ADDENDUM 01

July 24, 2026

Bradford Exempted Village Schools
New Athletic Facility
760 Railroad Avenue
Bradford, OH 45308

LPA PROJECT NO. 263401.00

FIRST FLOOR PLAN - POWER & SYSTEMS

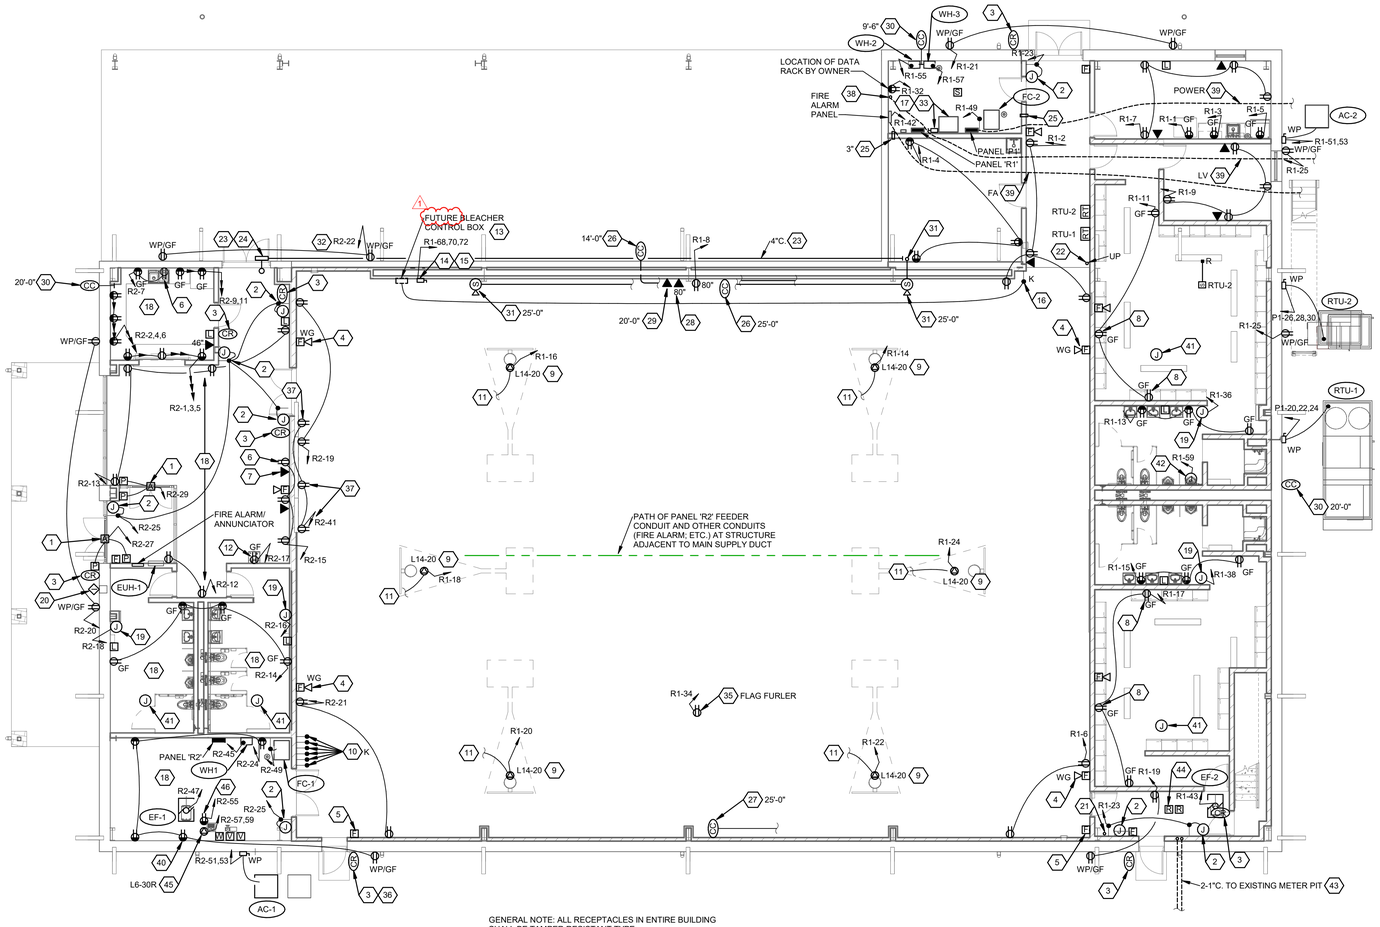
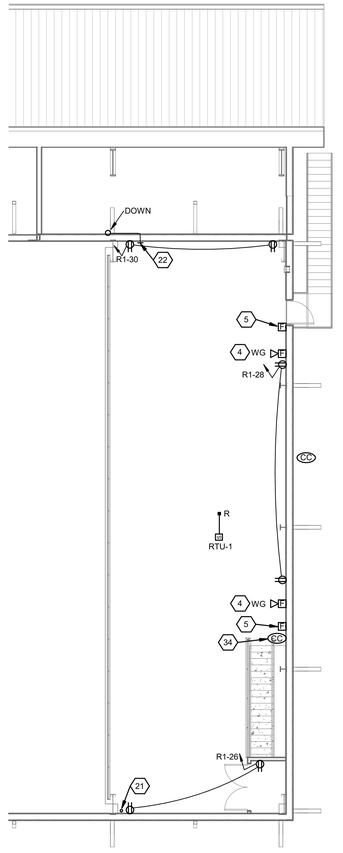
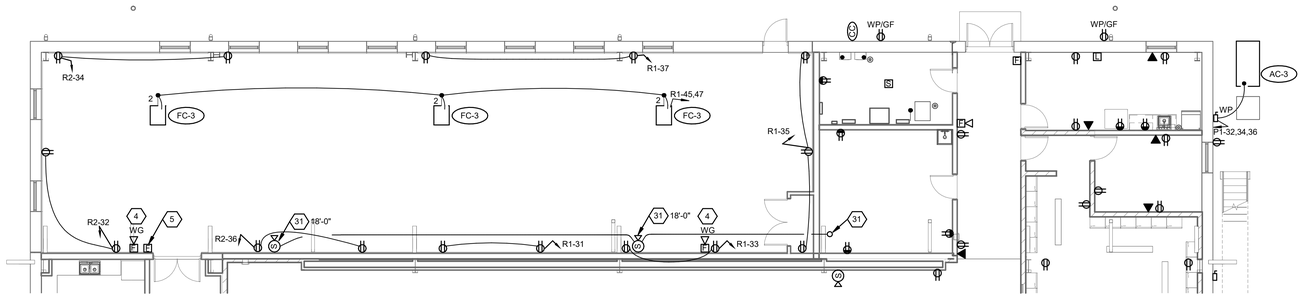
2.24 Sheet E1.2 – FIRST FLOOR AND MEZZANINE FLOOR PLANS – POWER AND SYSTEMS.

2.24.1 Bleacher Alternate G-2 has been deleted and bleachers will be provided by Owner at a later date. Please note that rough-ins for the future bleachers shall be included in the base bid. Revise notations for bleacher services as applicable. Refer to drawing issued with Addendum.
